Temporary Traffic Arrangement for Temporary Run-In Out for Construction Works at Ke Sheung Road near Nam Hing West Road

Applicant's letter ref. no. NU/OTH/011468 dated 16 Aug 2024

Agreed via fax (3747 3221) on 28 Aug 2024 with the following Approval Conditions :

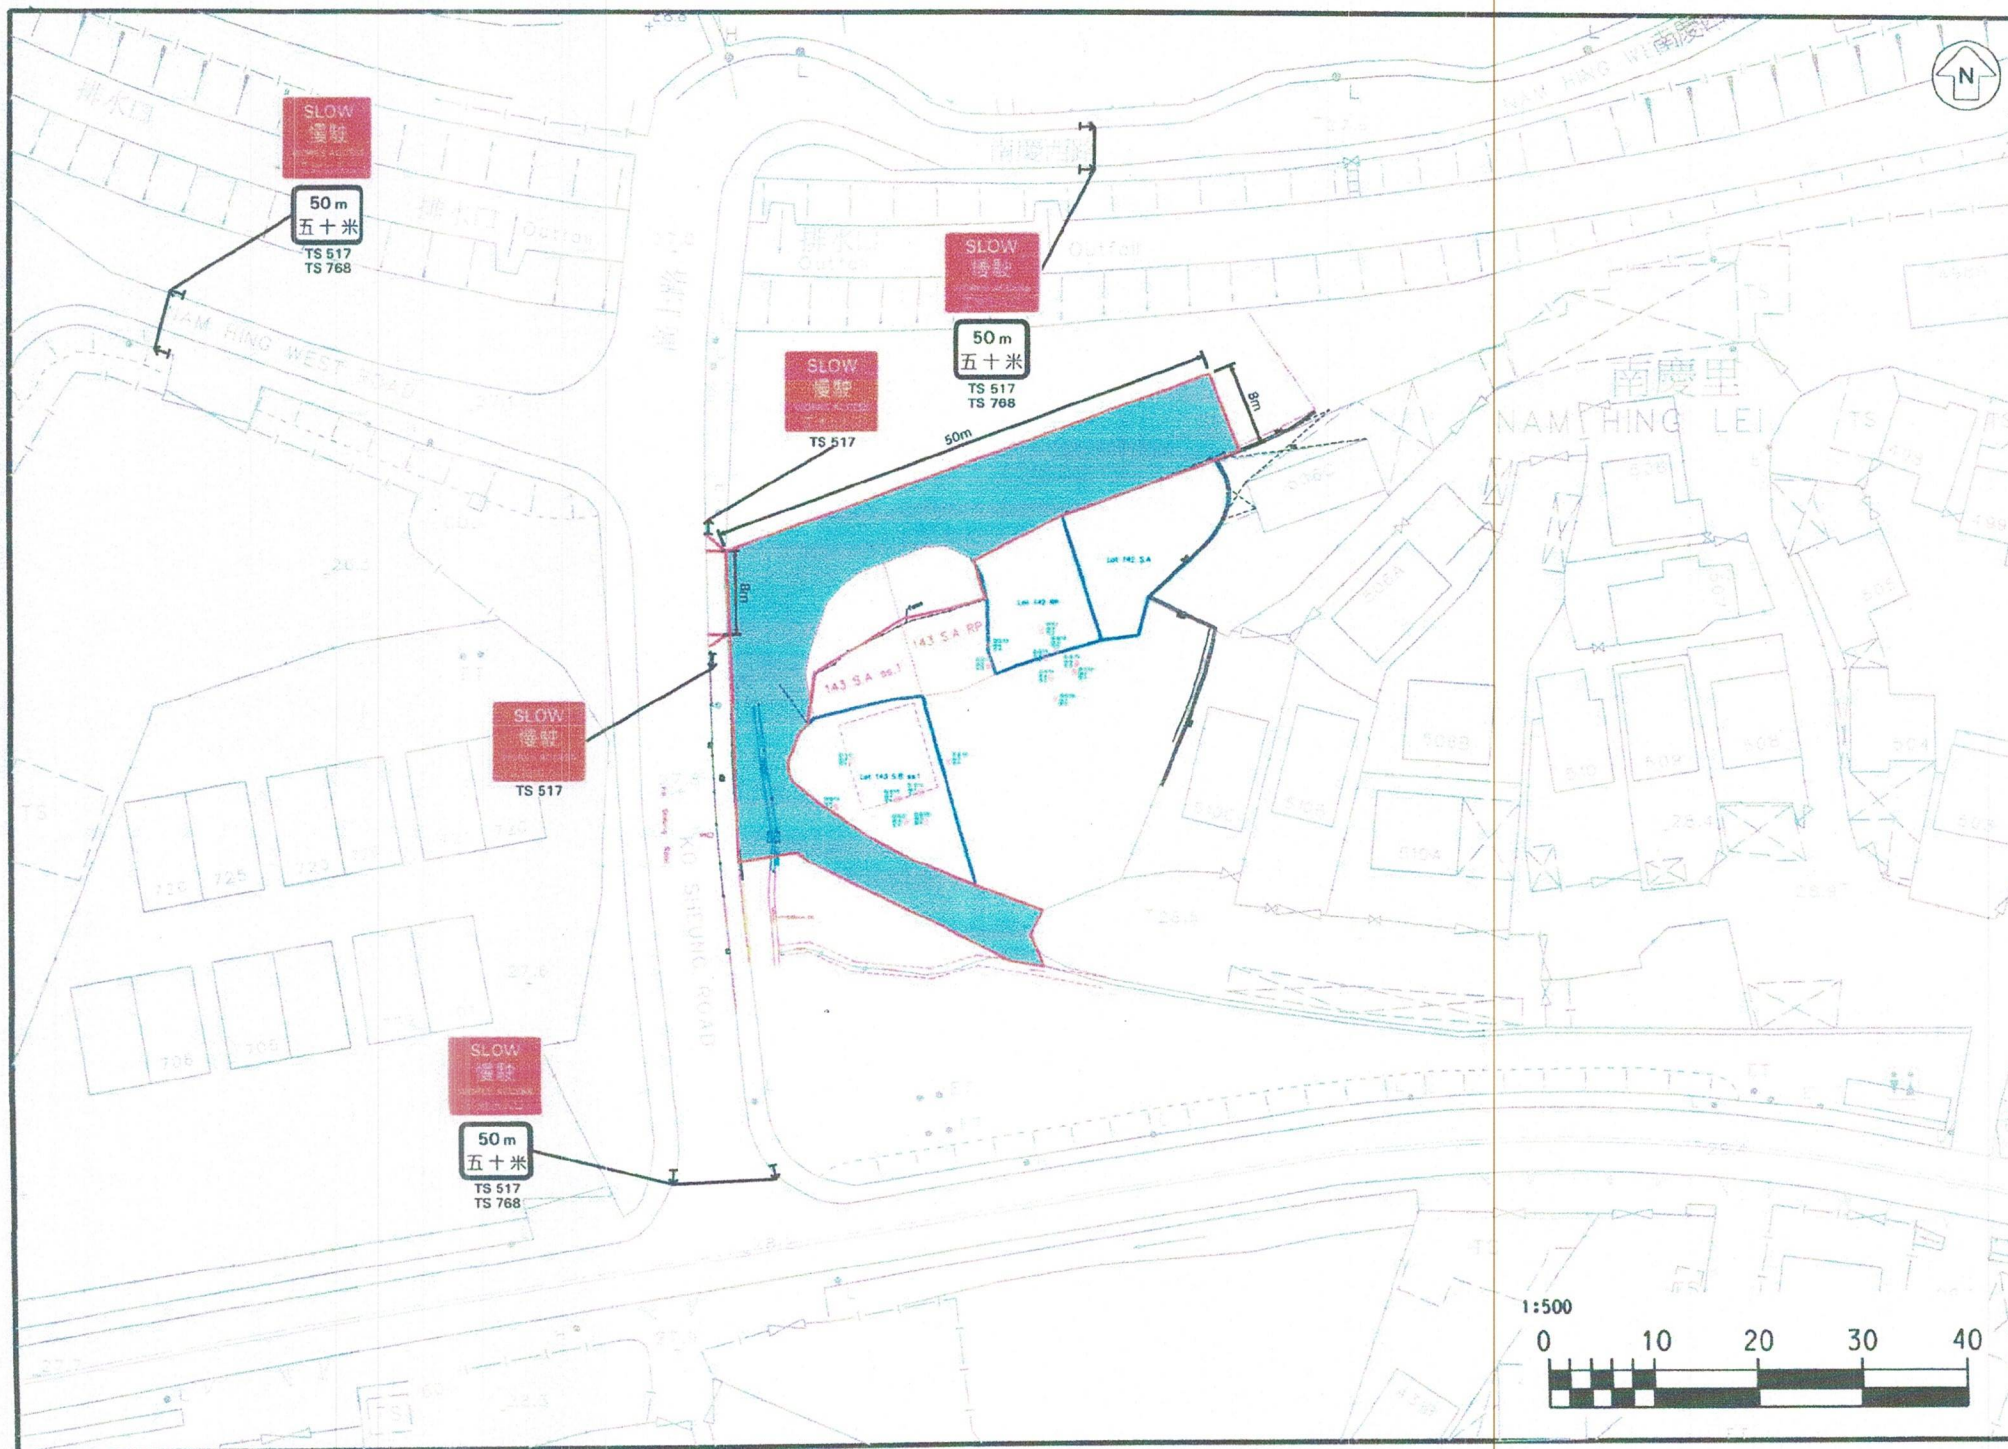
- 1) Please liaise with locals and affected stakeholders before commencement of the proposed works.
- 2) As the works area as shown is outside the purview of TD, please verify the road/land status, seek prior comments and obtain consents from relevant managerial departments/affected parties/stakeholders.

- 3) Please provide the purpose of works area in detail.
- 4) As the proposed vehicular access/run-in/out is temporarily implemented on a footpath, please submit relevant drawing in detail to lay out the TTA for implementation of such vehicular access and pedestrian traffic control on footpath during implementation.

- 5) Please also liaise with district maintenance division of Highways Department beforehand for any removal of existing street furniture such as type II railings on the back of footpath. Such railings shall be immediately reinstated upon completion of works.

- 6) The plastic barriers as shown shall be provided with flashing lanterns for 24-hour TTA/works and shall be specified on the legend.
- 7) Water-filled barriers rather than plastic barriers shall be provided along the back of footpath when there is an adjoining slope or retaining wall underneath, please verify on site accordingly.

- 8) The both sides of vehicular access/run-in/out shall be provided with amber revolving lanterns.
- 9) Banksman shall be deployed at the vehicular access/run-in/out for manual traffic control when necessary.

- 10) Swept path analysis of construction/works vehicle for ingress/egress at the vehicular access/run-in/out shall be demonstrated.
- 11) Adequate and unobstructed sightlines shall be maintained at/near the vehicular access/run in/out.

- 12) Please seek prior comments and obtain consent from Traffic Police.
- 13) Please ensure no other concurrent TTA scheme nearby unless prior approvals/consents granted by TD and Traffic Police.

- 14) Please revise the anticipated programme of works for six months maximum and submit application for re endorsement every six months.
